| Title: Charles Tyrwhitts Mezz Guard Assembly | | | Material As Per Part | | Dimensions mm 1 : 15 Projection <input checked="" type="radio"/> <input type="radio"/> |
| | | | Drg No. CTS - Guard Frame.iam | Edition A | Sheet Number 3 |

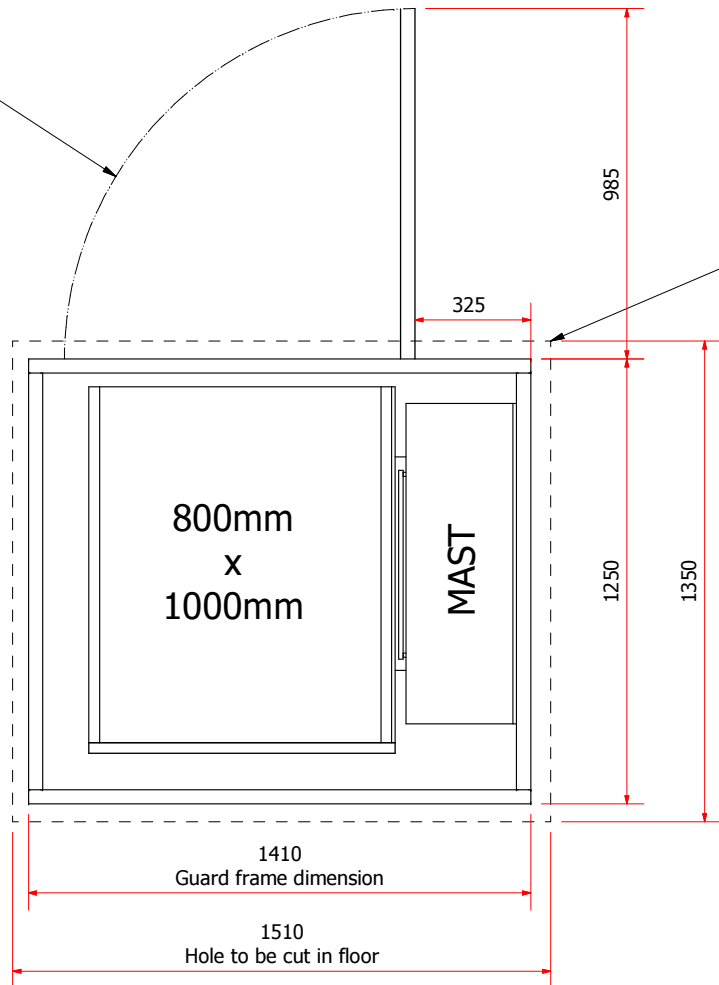
Make sure the floor posts do not sit within the door opening

Hole in existing mezzanine to be cut - 50mm clearance all round
